Crystal River Nuclear Plant
15760 W. Power Line Street
Crystal River, FL 34428

Subject: Crystal River Unit 3 – Response to Requests for Additional Information and Supplement 1 to License Amendment Request #316, Revision 0

LICENSE AMENDMENT REQUEST #316, REVISION 0

SUPPLEMENT 1 TO LAR #316 REVISION 0

Figure 3.7.15-2
Burnup versus Enrichment Curve for
Spent Fuel Storage Pool B

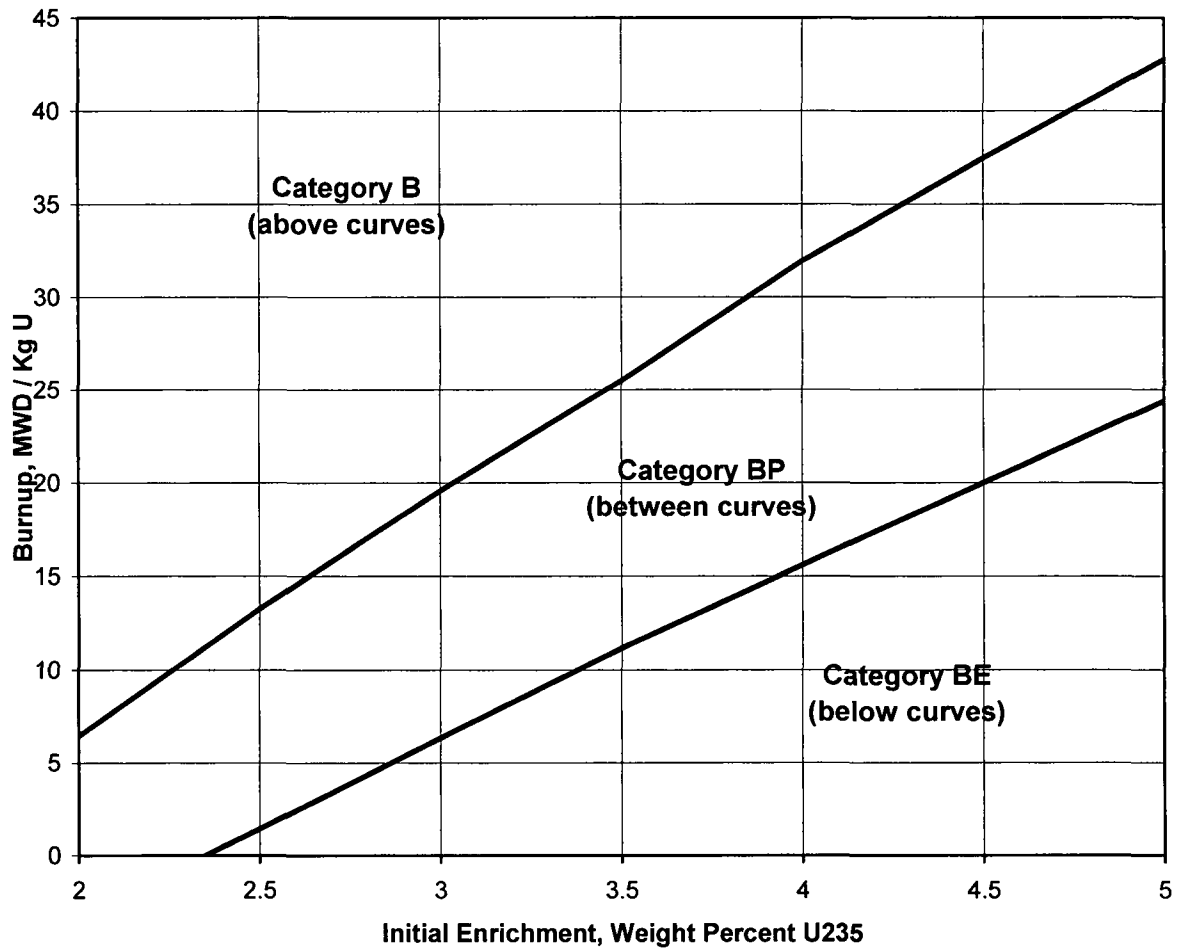
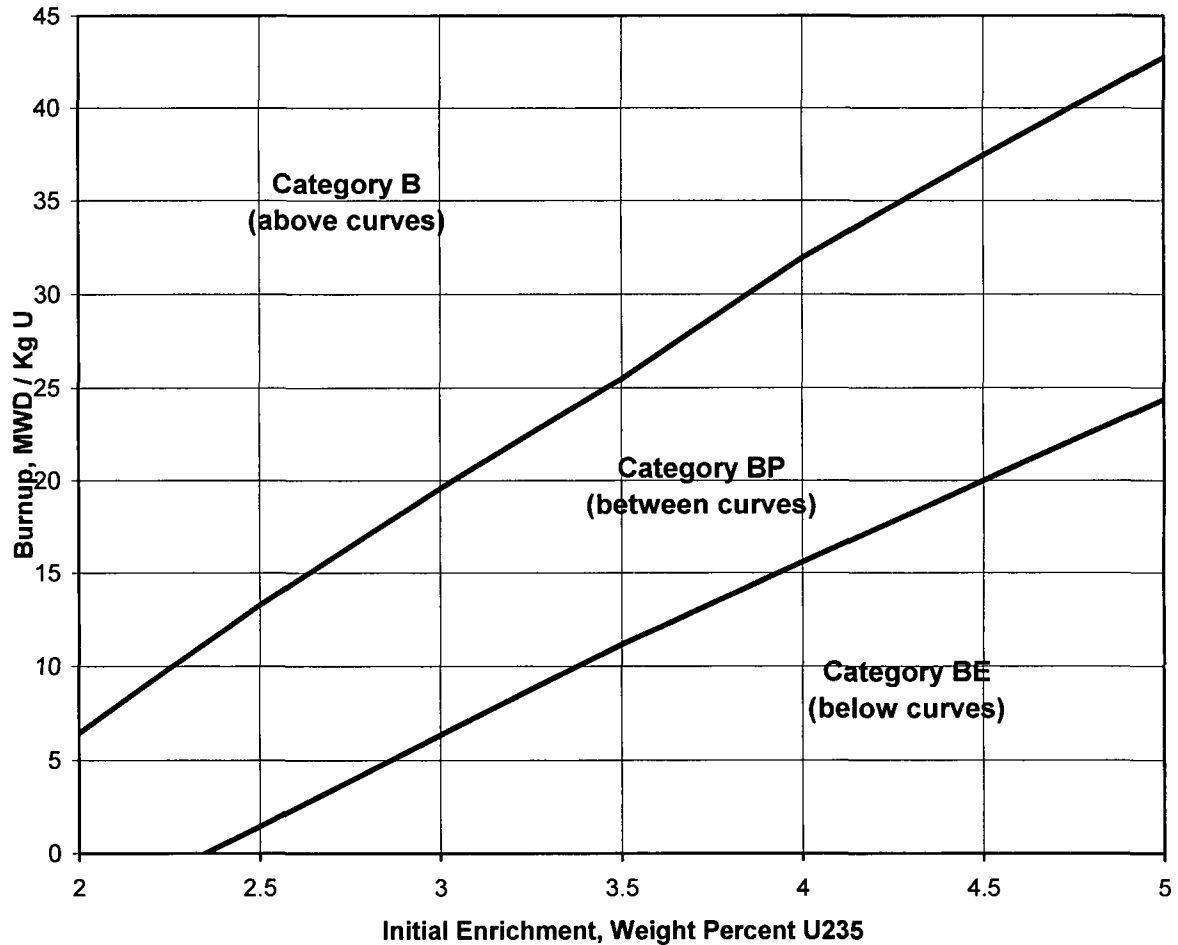
PDTs Figure 3.7.15-2 in both the strikeout and shadowed text format, and revision bar format in LAR #316, Revision 0, contained an incorrect page header. The Figure title is also incomplete in that it does not refer to pool 'B'. Corrected pages are included in this Supplement in Attachments E and F.

Attachment E contains the corrected PDTS page for this Figure in strikeout and shadowed text format, and Attachment F contains the corrected page in revision bar format.
